SUNDRY NOTICES AND REPORTS ON WELLS (DO NOT USE THIS FORM FOR PROPOSALS TO DRILL OR TO DEEPEN OR PLUG BACK TO A DIFFERENT RESERVOIR. USE "APPLICATION FOR PERMIT" (FORM C-101) FOR SUCH PROPOSALS.) 1. Type of Well: Oil Well <input type="checkbox"/> Gas Well <input type="checkbox"/> Other INJECTION		WELL API NO. 30-025-05755

4. Well Location Unit Letter <u>O</u> : <u>330</u> feet from the <u>S</u> line and <u>2310</u> feet from the <u>E</u> line Section <u>30</u> Township <u>19S</u> Range <u>37E</u> NMPM County <u>LEA</u>		7. Lease Name or Unit Agreement Name North Monument G/SA Unit [302708]

11. Elevation (Show whether DR, RKB, RT, GR, etc.) 3607 GR		8. Well Number <u>015 (1015)</u> 9. OGRID Number <u>873</u> 10. Pool name or Wildcat Eunice Monument; G/SA [23000]

Action 556203

Proposed Schematic

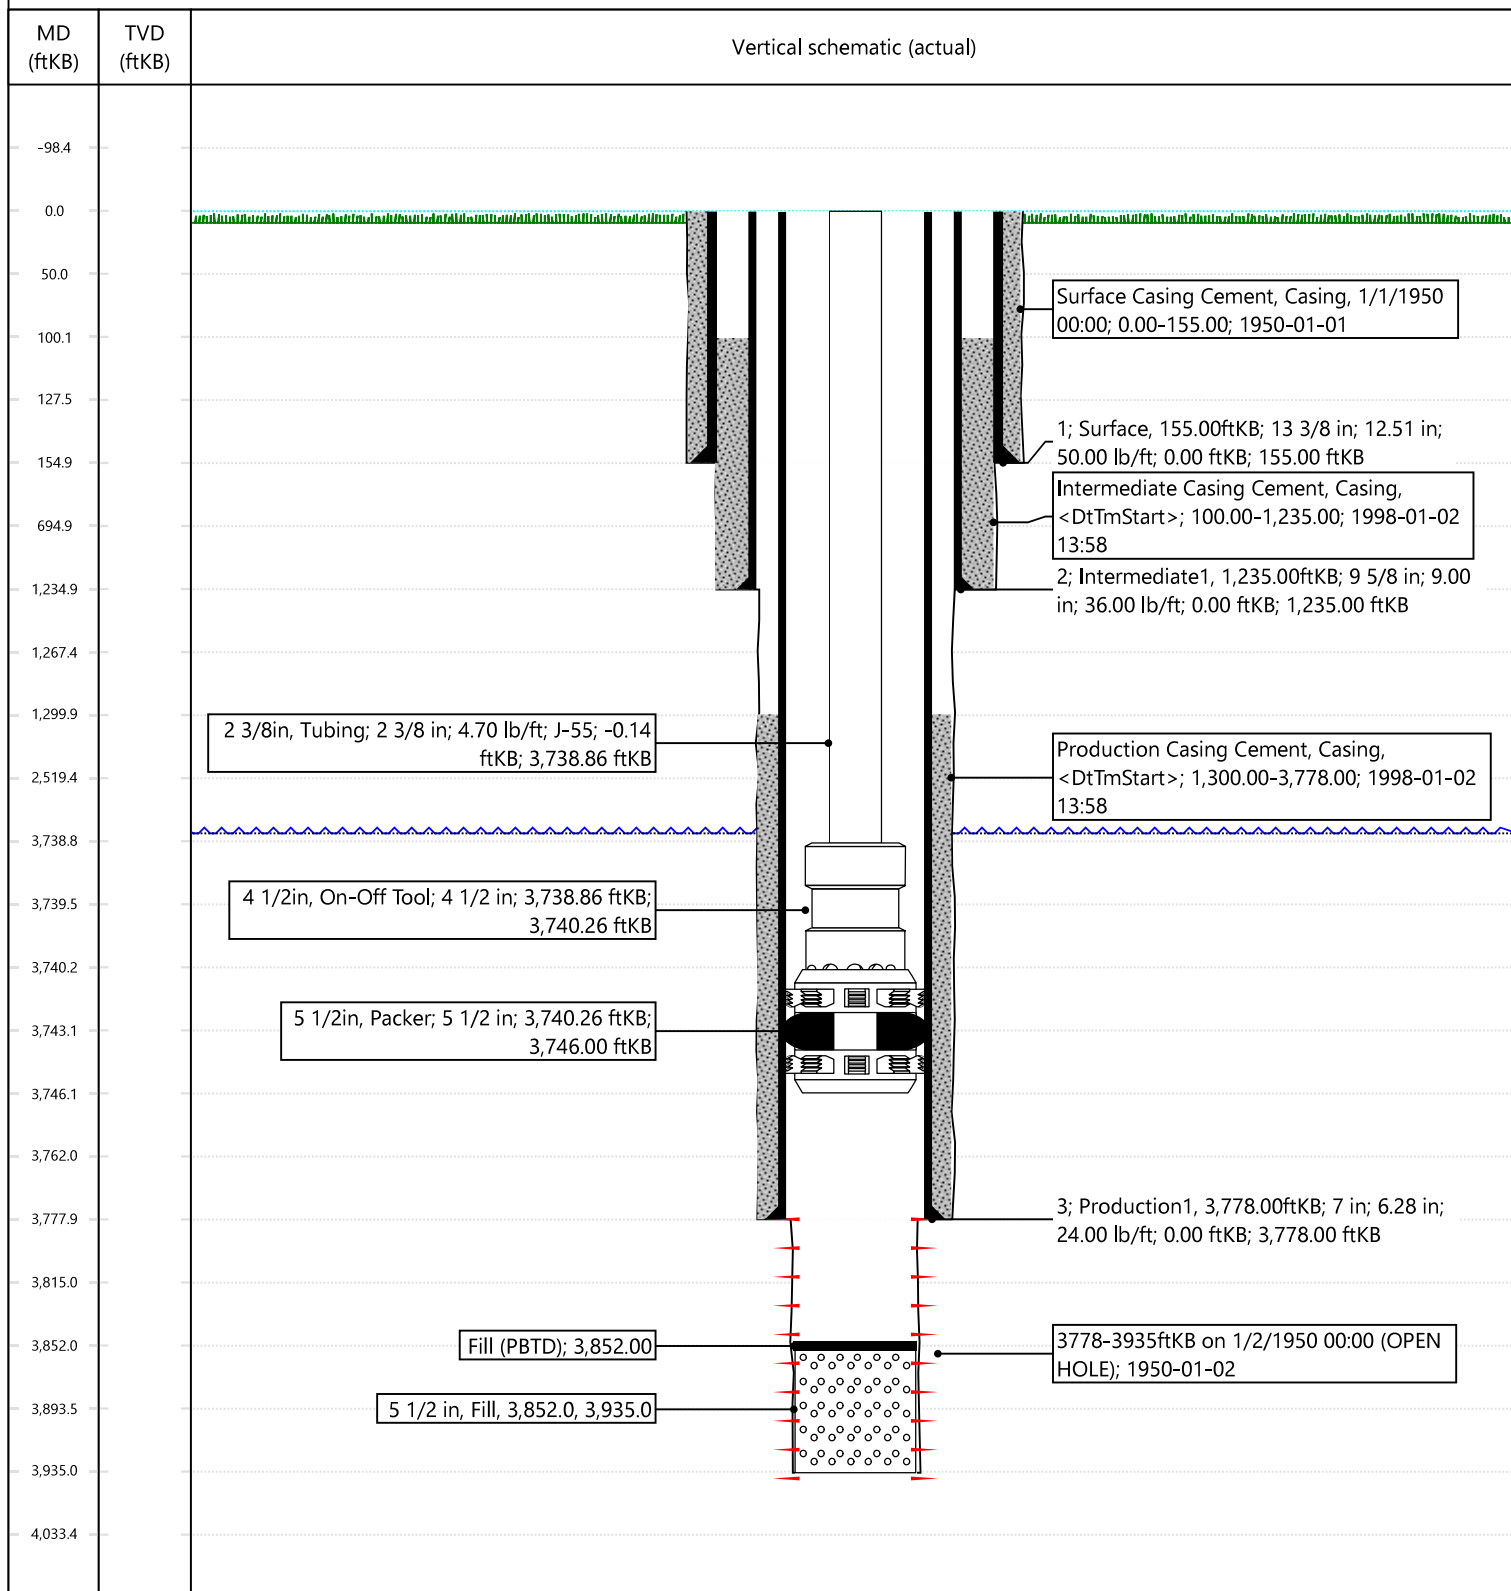
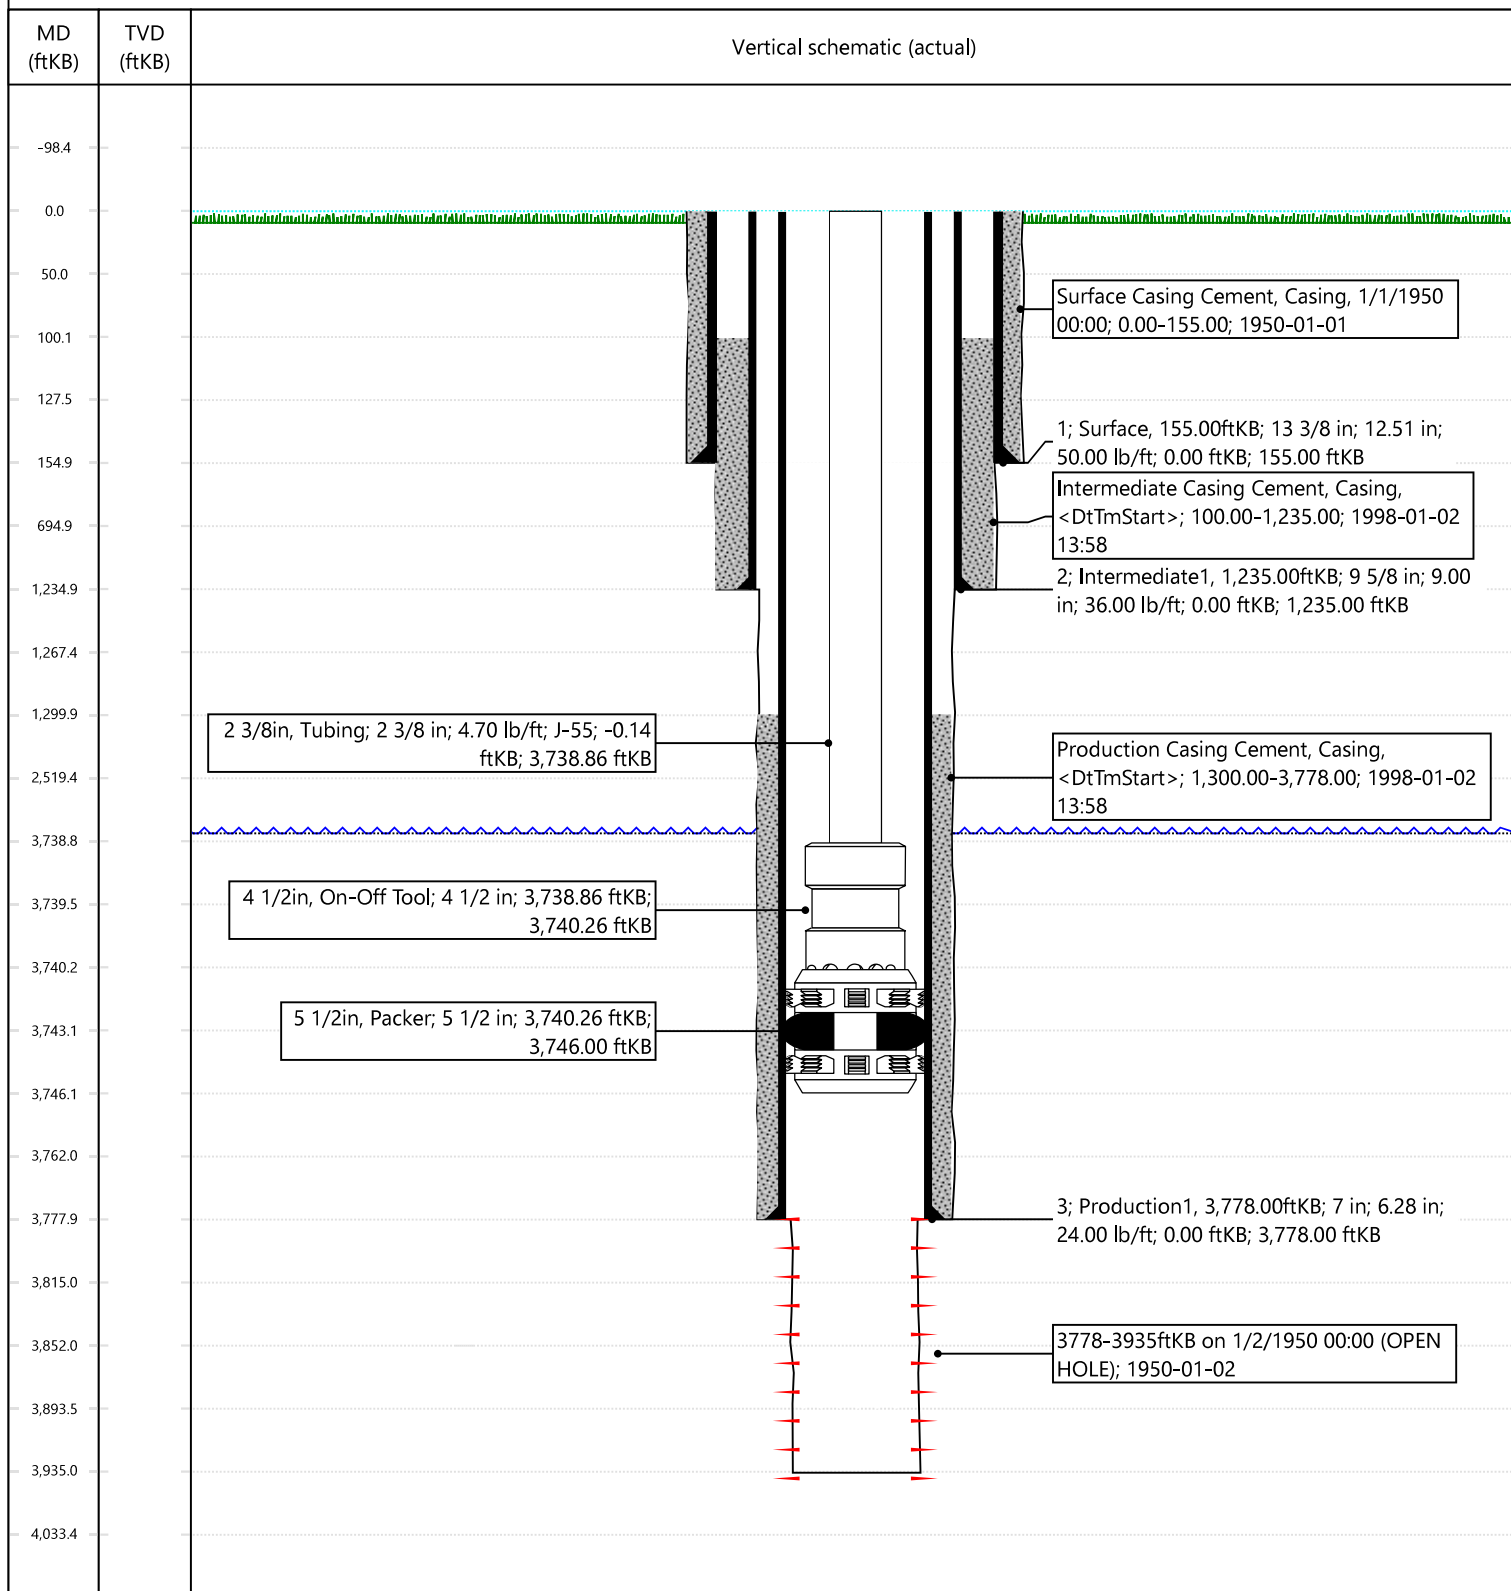
Hilcorp is requesting to rig up on this well and perform a clean-out to increase our injection rate. The proposed procedure is:

- 1 - MIRU, ND/NU, FUNCTION TEST BOP, KILL WELL
- 2 - RIH AND SET BLANKING PLUG, PRESSURE TEST TUBING TO 850 PSI FOR 5 MIN
- 3 - SCAN OOH WITH TUBING AND INJ PACKER, LD RB AND GB, REPLACE WITH SIMILAR SPEC TUBING
- 4 - PU BIT AND WS, RIH AND CLEAN-OUT TO ~3933', POOH W/BIT
- 5 - RIH W/TREATING PACKER TO ~3750', TEST CSG TO 600 PSI FOR 15 MIN
- 6 - PUMP 10,000 NEFE 15% HCl ACID JOB W/VENDOR RECOMMENDED ADDITIVES & OVERFLUSH VOLUME
- 7 - POOH W/TREATING PACKER AND WS
- 8 - RIH W/INJECTION PACKER AND TUBING, SET PACKER @ ~3740' (TOP PERF 3790', INJ PKR B/N 3690-3740')
- 9 - NOTIFY NMOCD WITH 24 HR NOTICE AND PERFORM WITNESSED MIT
- 10 - RETURN TO INJECTION, MAX INJ PRESSURE 750 PSI, RDMO

Created By	Condition	Condition Date
anthony.harris	No tubing upsize permitted	3/6/2026
anthony.harris	Post workover MIT required with OCD witness	3/6/2026
